## Request for Information (“RFI”)

Harrison, Town-Village Recreation Center Phase 2  
270 Harrison Avenue  
Harrison, NY 10528

#025

**PROJECT** Harrison **Job #** 24035 **RFI #** 3 **Date:** 01/27/25  
G.C. Piazza **REPLY REQUESTED** 02/03/25  
**ATTN:** Phil Pagnatelli  
**REGARDING** Sequence 12 Lintel Shop Drawing Markups - Design Changes

SHEET #: 12E1

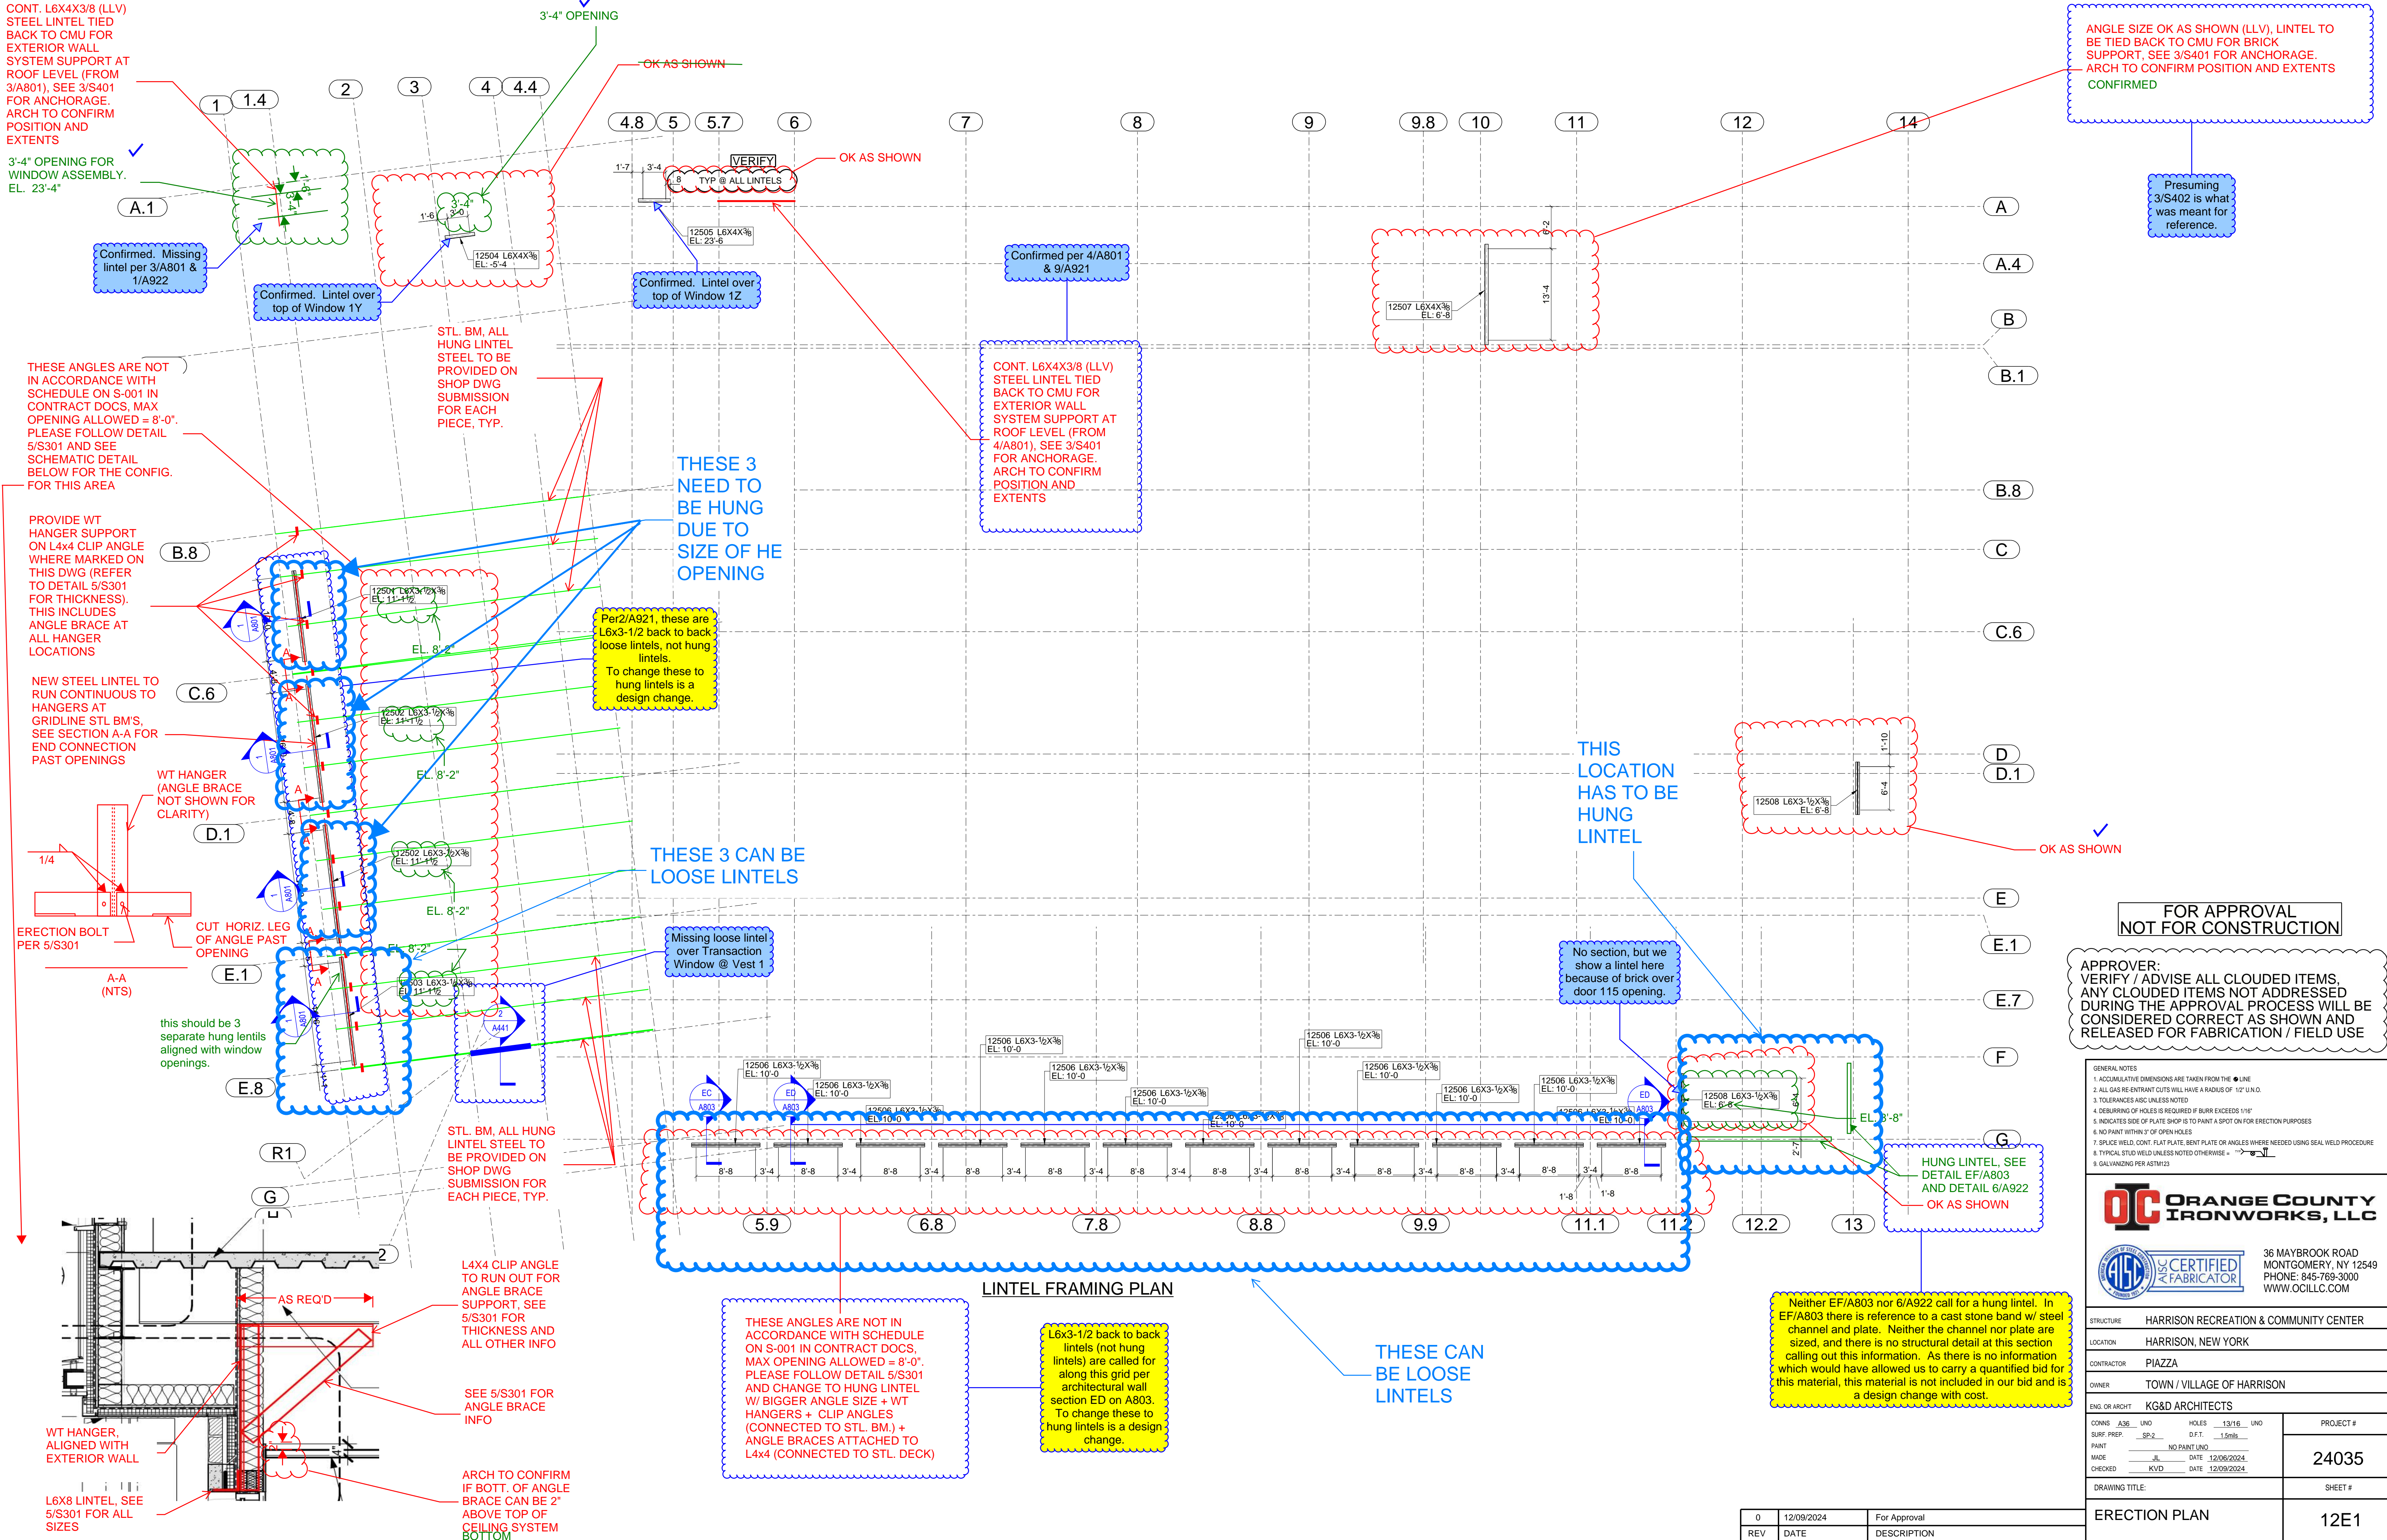
Please see attached marked up version of 12E1 which was returned with submittal \_051200-20\_Shop Drawings\_Loose Lintels - TDEG RR KGD.

There are notes along Grid 1 and Grid G which reference loose lintels (shown as loose lintels on the architectural drawings) to be revised to hung lintels (not shown on the structural drawings). Design change comments are noted in yellow highlight.

These changes from loose lintel to hung lintel have a significant cost impact for material, shop labor, and field labor.

Please review the markups and either confirm loose lintels as shown in the architectural drawings are acceptable or confirm Owner direction to proceed with design change.

ANGLE SIZE OK AS SHOWN (LLV), LINTEL TO BE TIED BACK TO CMU FOR BRICK SUPPORT, SEE 3/S401 FOR ANCHORAGE. ARCH TO CONFIRM POSITION AND EXTENTS  
CONFIRMED

Presuming 3/S402 is what was meant for reference.

IT IS ACCEPTABLE TO USE LOOSE LINTELS WHERE INDICATED ON THE ATTACHED OCI DRAWING MARK UP. HUNG LINTELS ARE REQUIRED WHERE NOTED DUE TO THE SIZE OF THE OPENING. SEE 5/S301 OF THE BID DOCS FOR TYPICAL HUNG LINTEL DETAIL. CONTRACTOR TO COORDINATE WITH LINTEL SUBMITTAL AS THERE WILL BE TWO METHODS OF INSTALLATION DEPENDING ON THE SIZE OF THE OPENING.
